Assessment of Pacific Gas & Electric Company's Pipeline Safety Enhancement Plan

**Prepared For
Consumer Protection & Safety Division**

December 23, 2011

For Jacobs Consultancy,

Figure 5 - PG&E Program Management Organization Structure

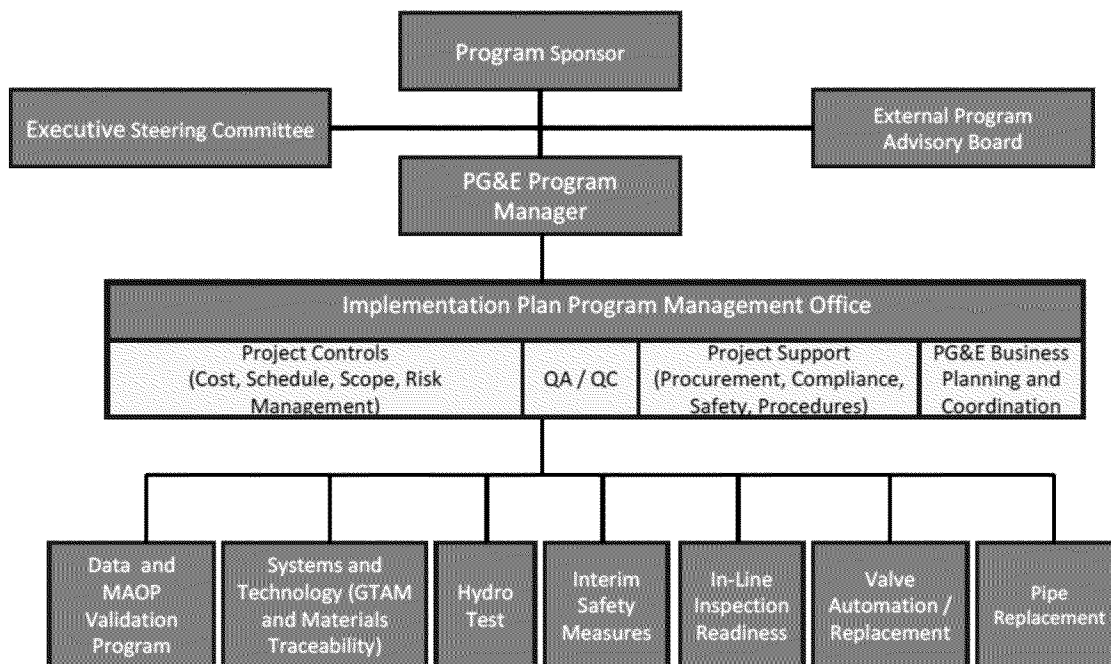
- The Implementation Plan PMO organizational structure looks to provide a good framework. The organization and governance is based on current industry practices.

- Before transitioning the PMO activities from the outside contractor to PG&E, the Implementation Plan PMO should be functioning as a high performance team. A 12 to 18 month transition period appears reasonable to achieve this transition.

- 8.4.1 PG&E should be required to provide a copy of its PMO project execution/ management plan for the PSEP in a format specified by the CPUC.
- 8.4.2 PG&E should report to the CPUC monthly the forecast and actual contingency draw down in a format specified by the CPUC.
